WDNR Second Incompleteness Determination Letter dated March 11, 2025

Subject: Second Incompleteness Determination for the Feasibility Report for the Proposed
Vernon County Landfill Eastern Expansion, License #3268

The Department of Natural Resources (department) has reviewed for completeness the report entitled "Feasibility Report Addendum 1- Proposed Eastern Expansion (WDNR License No. 3268)" dated November 19, 2024. The feasibility report (the report) was prepared by Short Elliot Hendrickson Inc., (SEH) on behalf the Vernon County Solid Waste Department. The department received the report on November 19, 2024. Based on the report review, the department has determined that the feasibility report does not contain the minimum information required by ch. NR 512, Wis. Adm. Code. Therefore, the report is not complete.

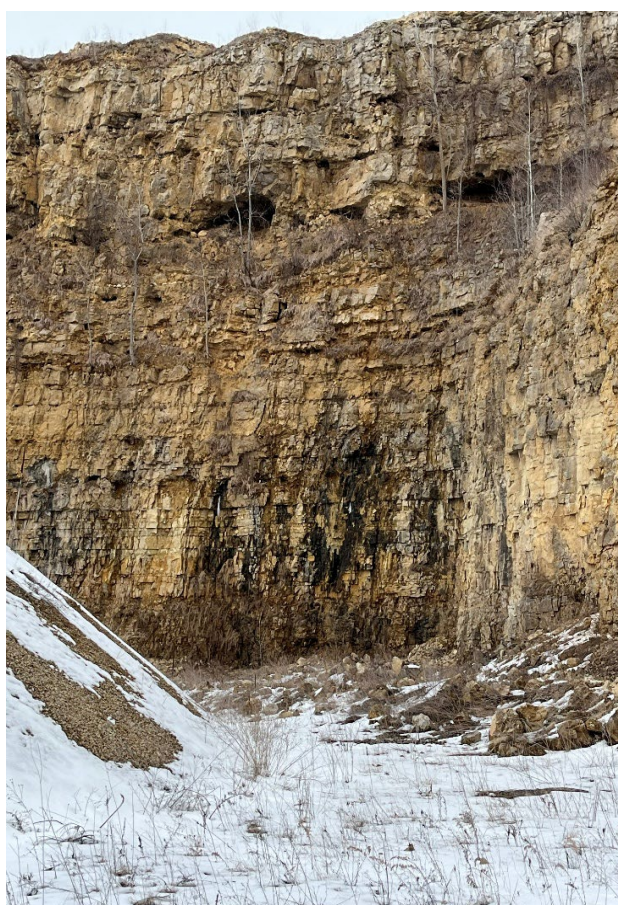
Large cave like structure observed at the Seas Branch Quarry. How does this observed structure correlate or not correlate with the rock borings at the landfill site?

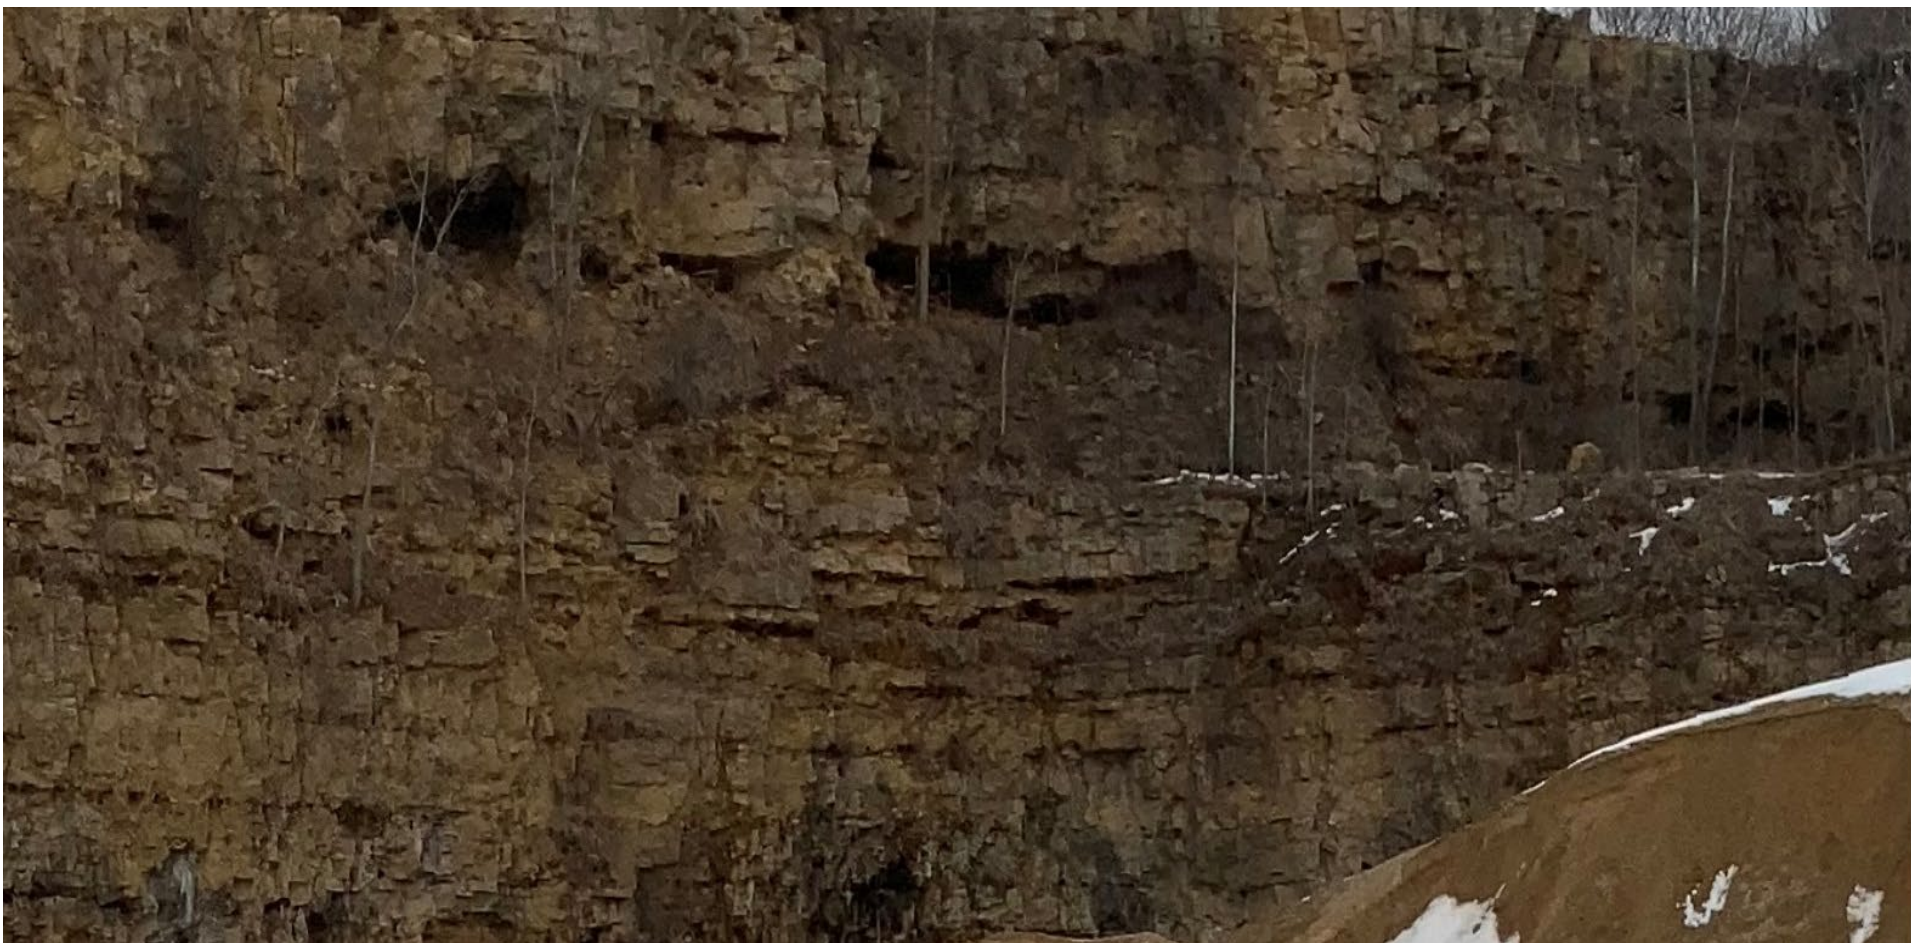
Frozen water observed at discreet locations in the rock at Seas Branch Quarry. What is the significance of this as it relates to the landfill site?

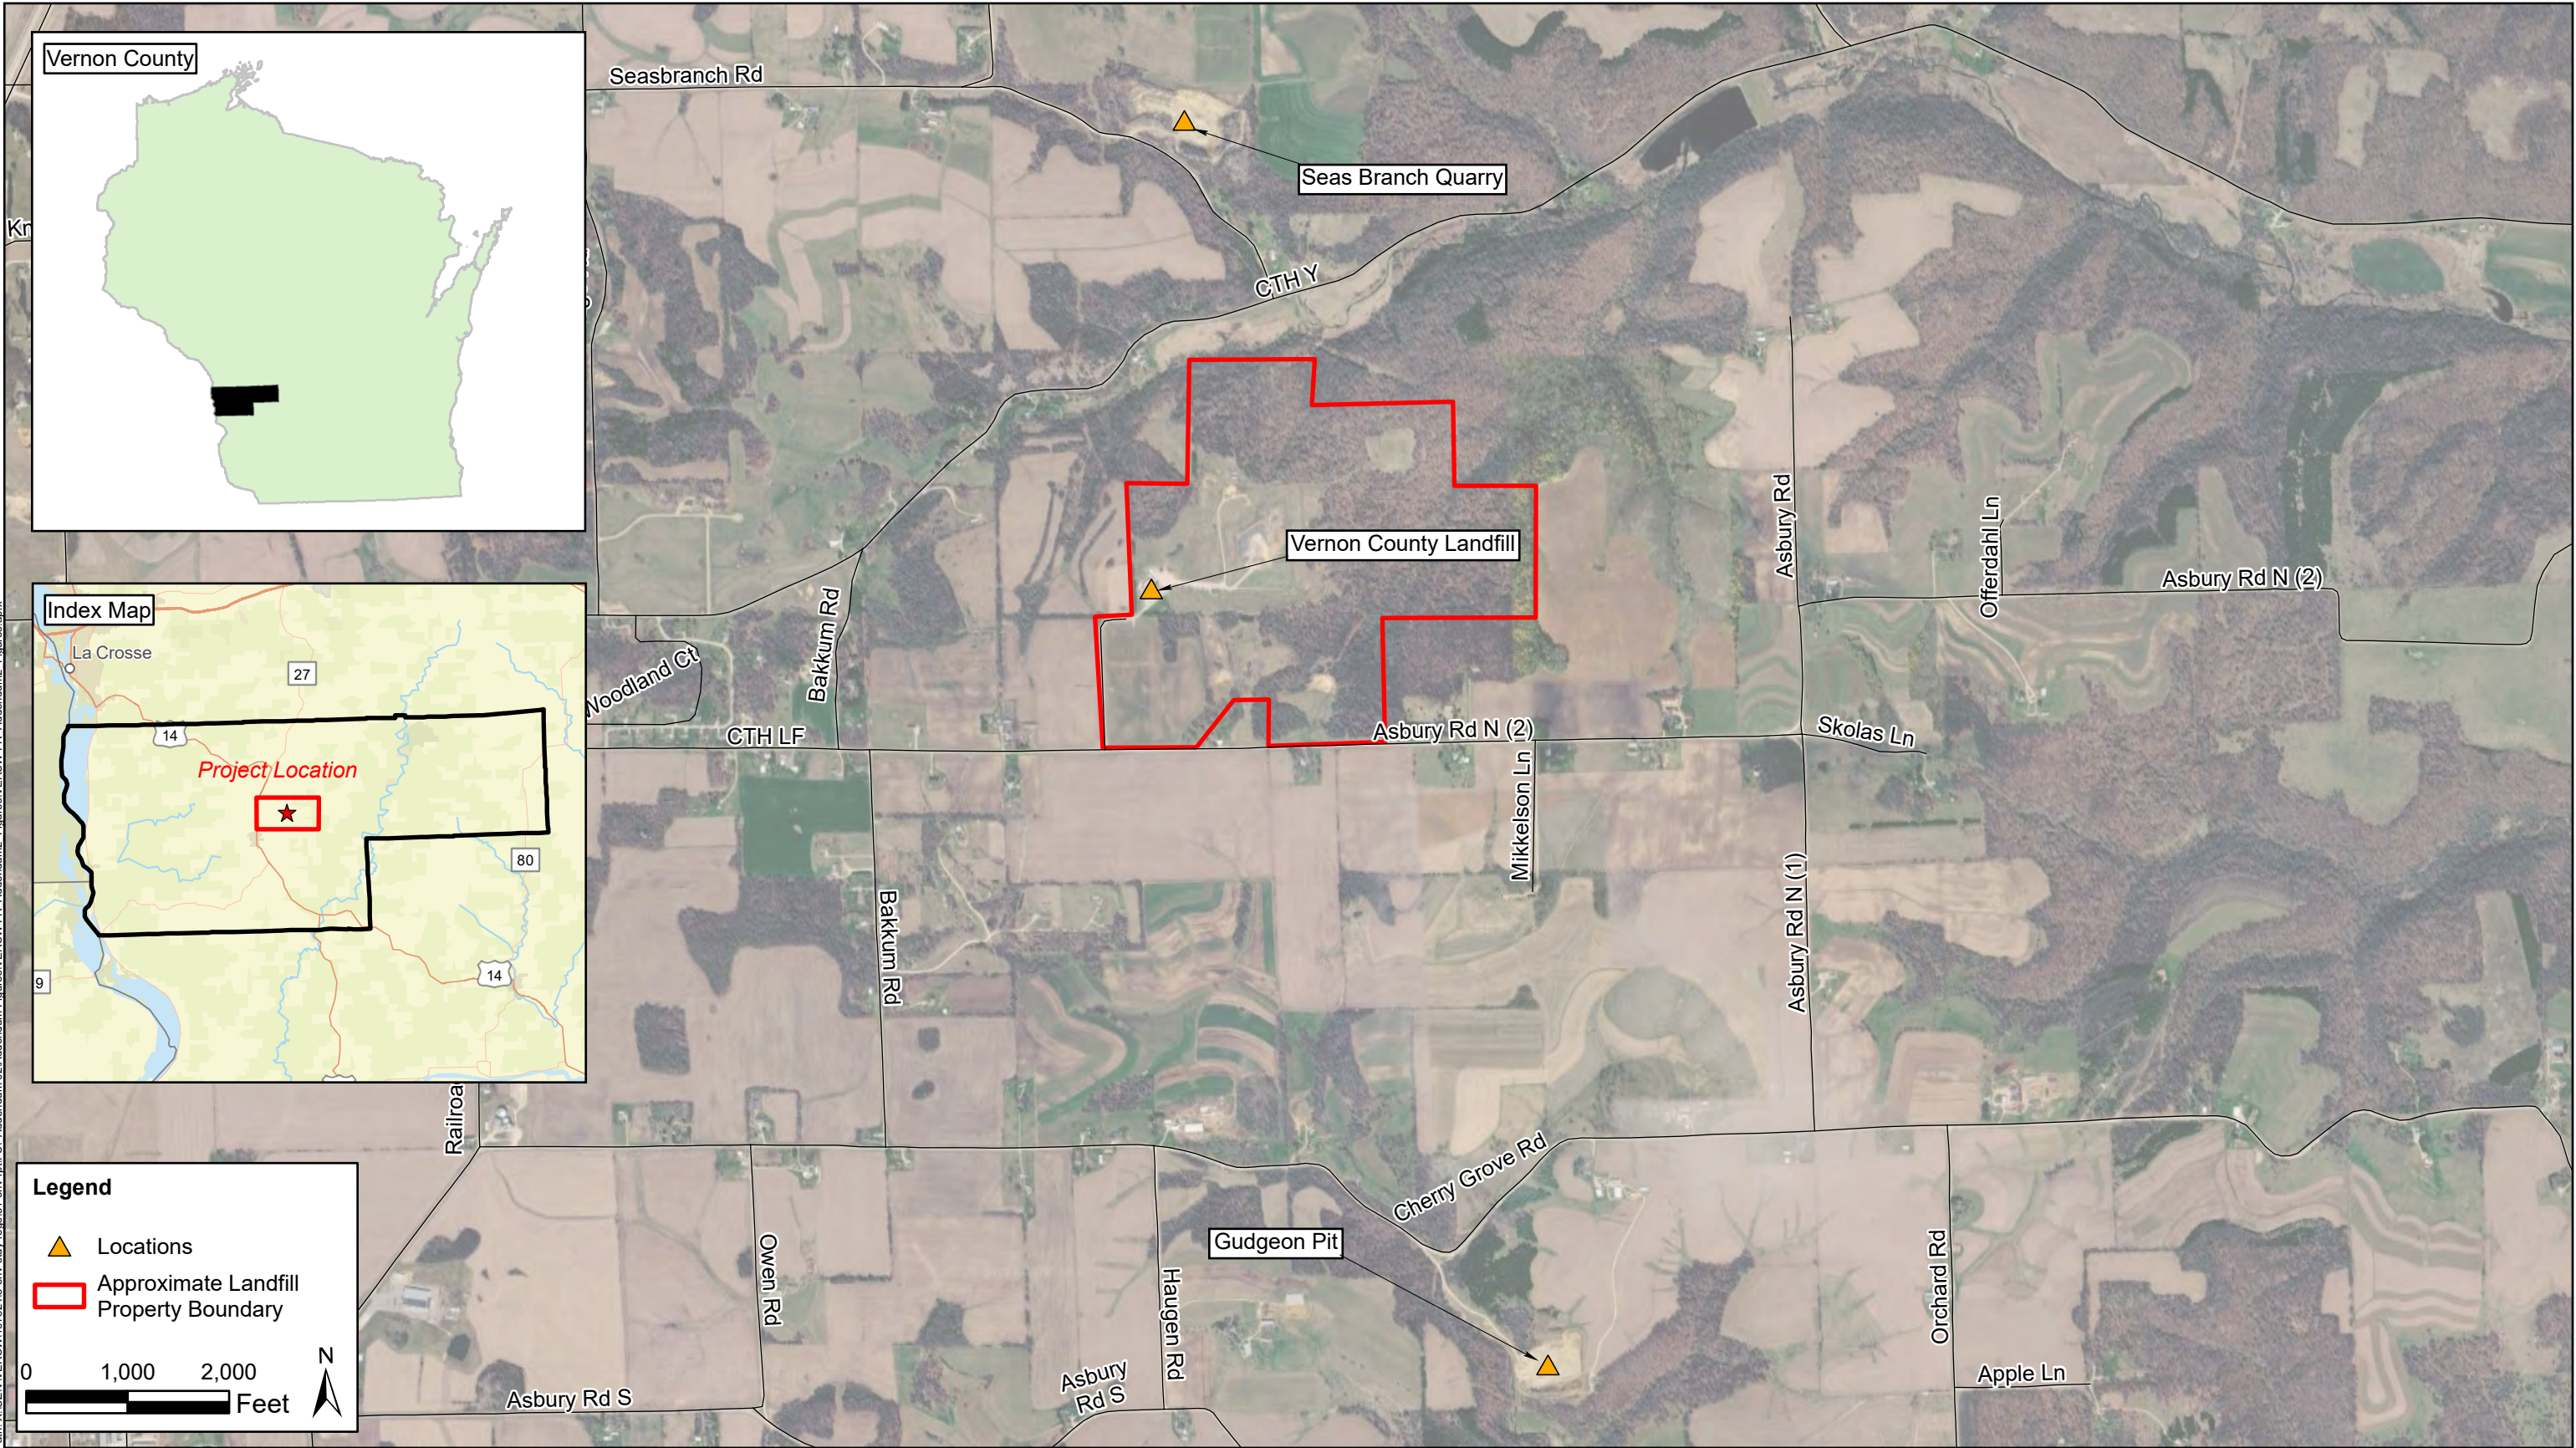
Cavities or voids observed in the upper part of the Praire du Chien. How does this relate to the landfill site?
